100G CR Review

Cu Cable Comments

Sam Kocsis

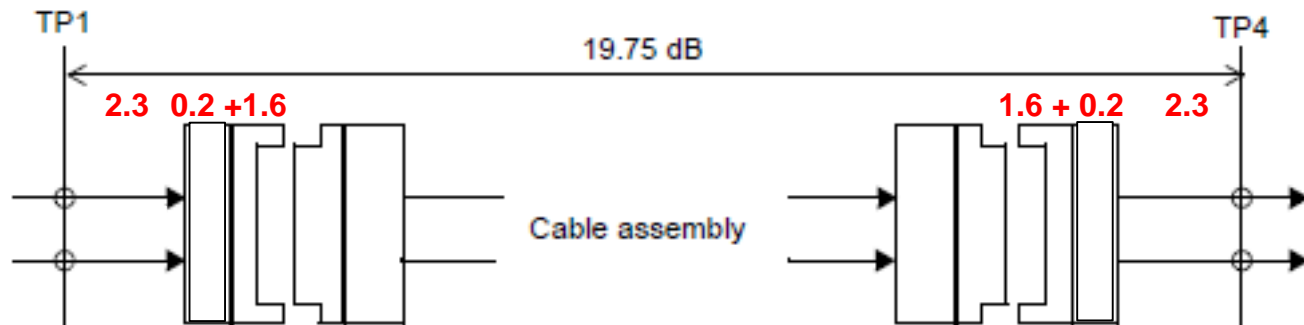
$IL_{Chmax}(f)$ is the maximum channel insertion loss in dB between TP0 and TP5

$IL_{Camax}(f)$ is the maximum cable assembly insertion loss in dB (TP1 to TP4)

$IL_{Host}(f)$ is the maximum insertion loss in dB from TP0 to TP2 or TP3 to TP5 using **TBD**

$IL_{MatedTF}(f)$ is the reference insertion loss in dB of the mated test fixture using Equation (162B-1)

$$\text{Cable Assembly}^* = 19.75 - 2 * 2.3 - 2 * (1.6 + 0.2) = 11.55 \text{ dB}$$
